September 29, 1994
Commission No. 2449-01-01-02

RE: Pavement Recommendations for a portion of Brittany Knolls
First Filing, Larimer County, Colorado

RE: Revised Pavement Recommendations for a portion of Brittany Knolls First Filing, Larimer County, Colorado

RE: Revised Pavement Recommendations for a portion of Brittany Knolls First Filing, Larimer County, Colorado

BORING LOGS

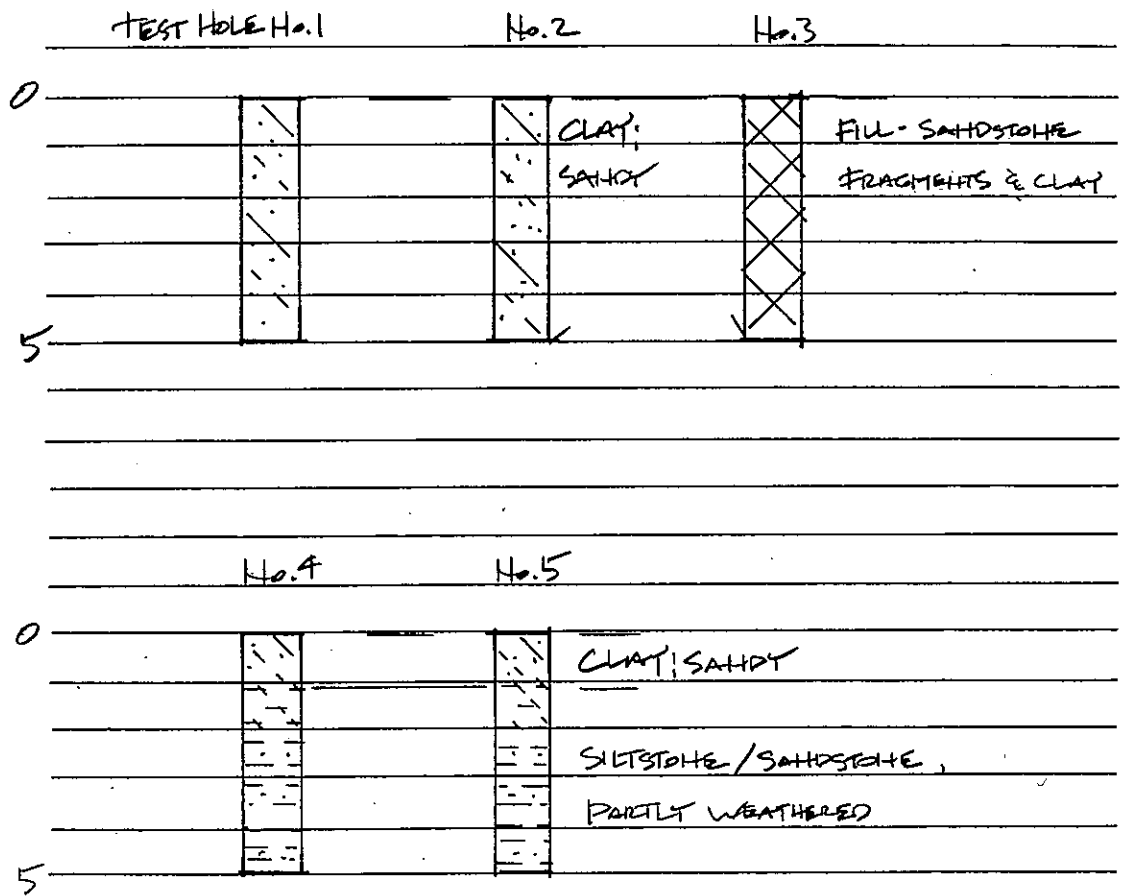
*Too sketchy
- Bed rock?*

Where is
